Sehr geehrte Händler,

bitte beachten Sie, dass mit sofortiger Wirkung folgende Maschinen

- TurfBoy TB1
- BandStreuer BS800

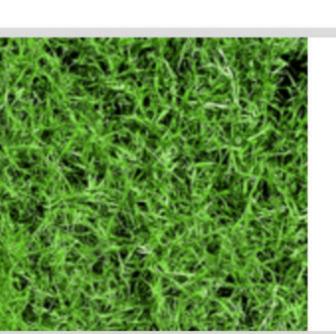
ein Heckbesen-Upgrade erhalten haben. Der Heckbesen wird jetzt nicht mehr klappbar sein, sondern starr wie beim TurfBoy TB2.

Vorteile des starren Besens im Gegensatz zum ausklappbaren Besen:

- Kein Hüpfen/Aufschaukeln bei der Fahrt
- Vermindertes Risiko einer Kollision an Pfosten/Bande
- Reduzierte Produktionskosten
- Wiederverwendbarkeit von gleichen Teilen (TurfBoy und Bandstreuer)
